PacifiCorp - Stakeholder Feedback Form

2019 Integrated Resource Plan

***IRP Topic(s) and/or Agenda Items:** List the specific topics that are being addressed in your comments.
Transmission

Benchmark Case (C-01) Transmission Upgrades

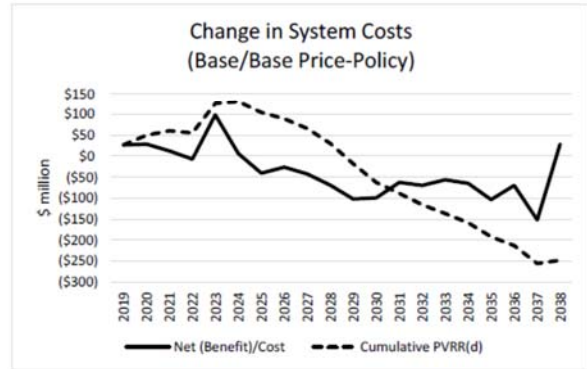
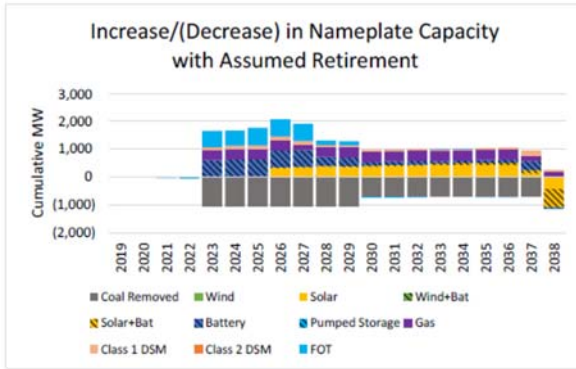
2. PacifiCorp should provide an updated list of transmission upgrades that SO selects in the top portfolios.

PacifiCorp first presented the below information in its December 3-4 presentation, and then updated it in the April 25 presentation. In both versions Gateway South (Aeolus to UT South) was selected in 2032. PacifiCorp should provide updated information on what transmission upgrades are being selected in what order, and the capital cost of the selected upgrades.

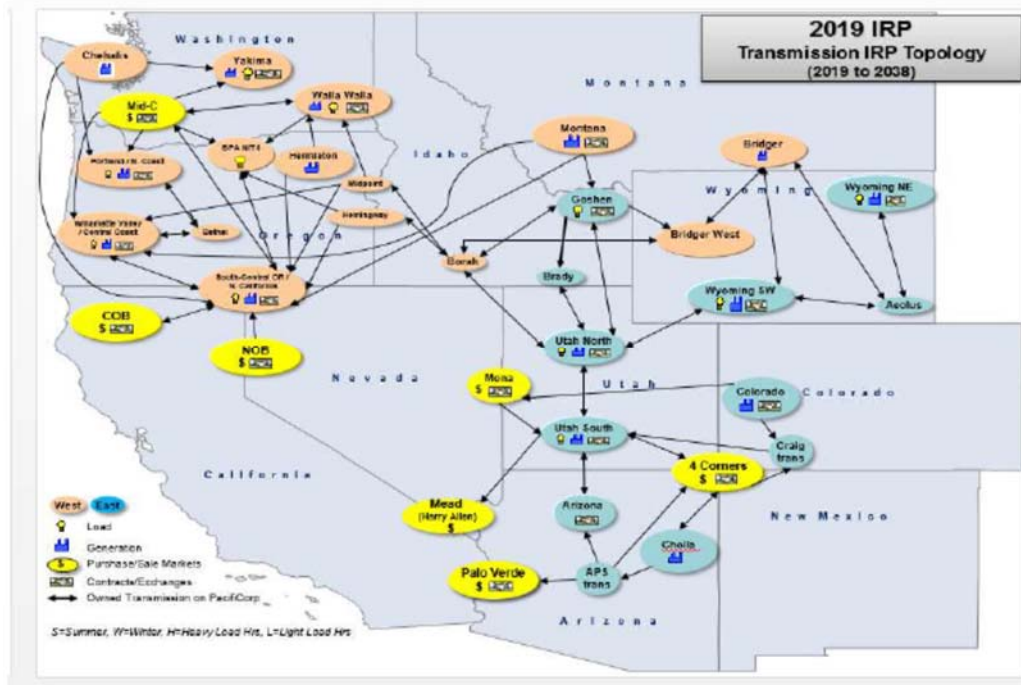
4. PacifiCorp should provide the information necessary for Staff to understand whether the IRP modeling process appropriately considers all available transmission on existing lines before building new transmission. Toward providing information necessary for Staff to feel confident in PacifiCorp’s transmission modeling, PacifiCorp should:
 - a. Provide a list of all generation that is selected before the model selects Gateway South in a few top IRP portfolios. The list should include the type, year, size, location, whether any tax credits are assumed, and whether any transmission upgrades are required to build the generation.
 - b. Provide more transparency into endogenous selection of transmission resources in SO through a stakeholder transmission modeling workshop.

In response to previous Staff requests to better understand whether SO is able to utilize all available transmission before selecting new transmission resources, PacifiCorp responded by directing Staff to see the below IRP transmission topology, stating that “transmission is available at these locations.” This graphic is unclear on the amount of available transmission, and Staff requests a transmission analysis that describes in better detail the quantity and location of transmission available to the SO model before it selects new transmission resources. This should include a demonstration of whether and how SO models transmission constraints.
